Location of Leased Premise **CALANDRA LOOKOUT** **MONTEREY COUNTY**
Agency Department of Forestry & Fire Protection **Real Property** #429

COMMUNICATIONS VAULT LEASE

AMENDMENT NO. One

Subject: CDF Radio Vault Space Application (TD-312) Modification
County of Monterey - L-0058
Calandra Lookout, Monterey County
CDF-VLT LCDF001154

ANTENNA SPACE ASSIGNMENT (140 FOOT TOWER)

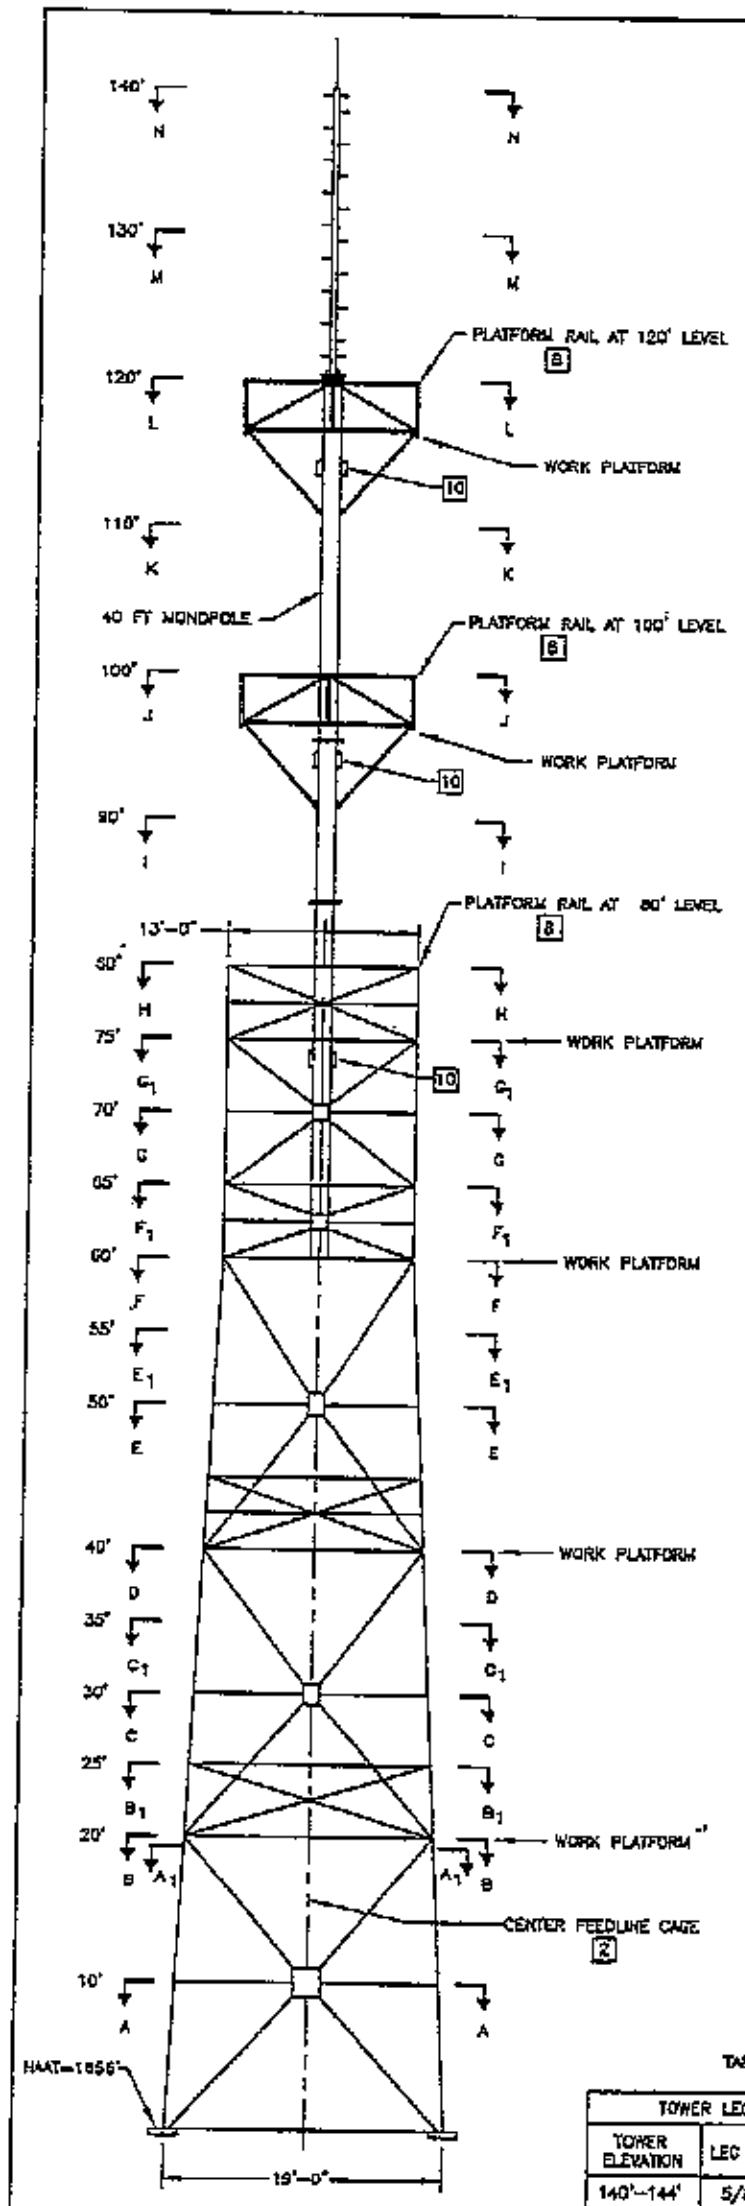
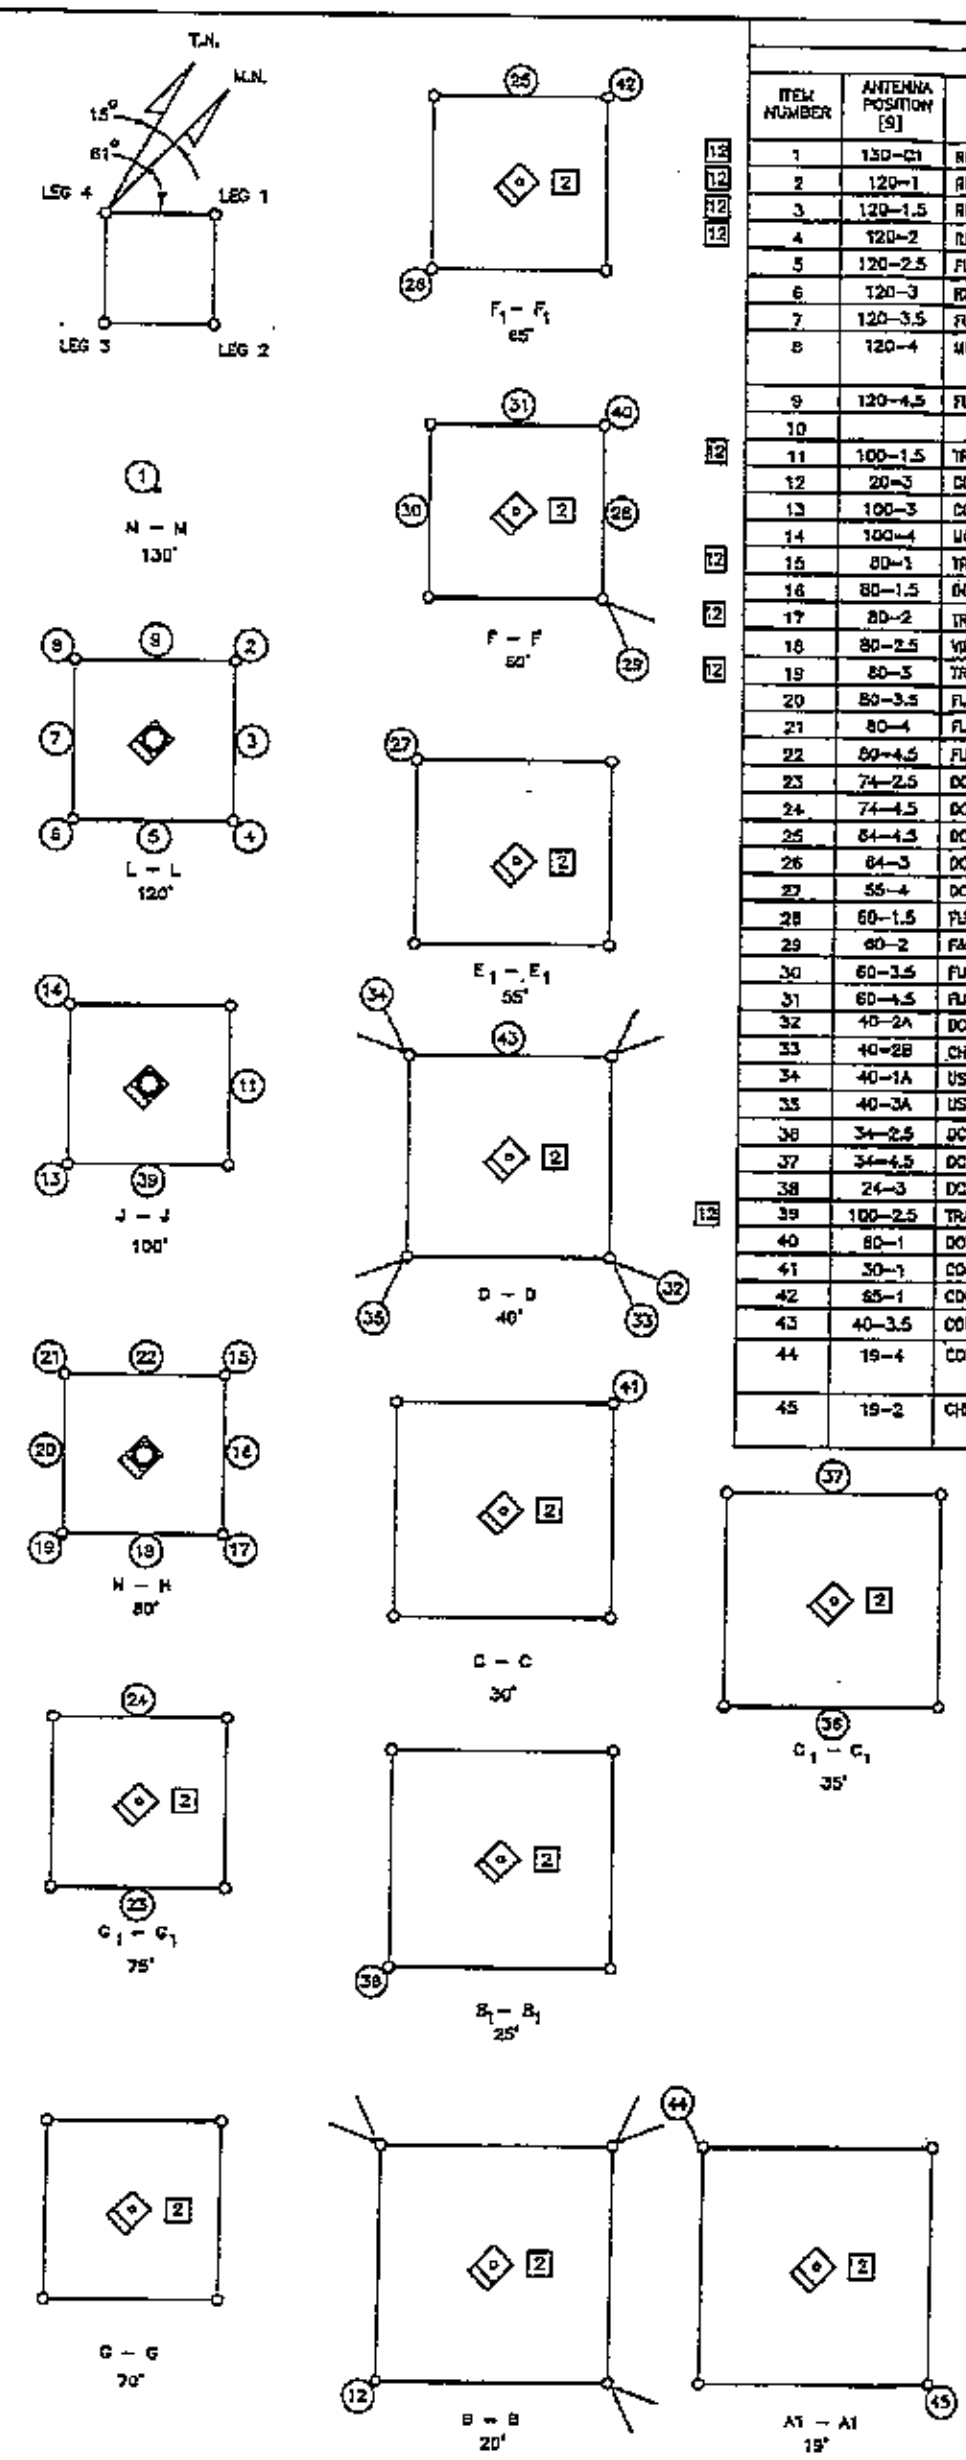
REV	DATE	BY	DESCRIPTION	APPD
S	2-25-14	BK	REMOVE ANTENNAS #10, #12 AND #13 PER EMAIL 2-10-14 FROM CDF	CB
R	9-20-13	SF	FAC-CDM131401W013: ADDED FAG TX ANT #29, UPDATE SILD	MR
V	10-28-15	BK	ADDED MONTEREY CO ANTENNAS #12&13, MOVED ANT #44 AND CHANGED TYPE	RF
U	9-9-15	KM	CHP12020W002: ADD ANTENNA #45	JN
T	7-21-14	BK	000001W012: INSTALLED ANTENNA #16	JAK
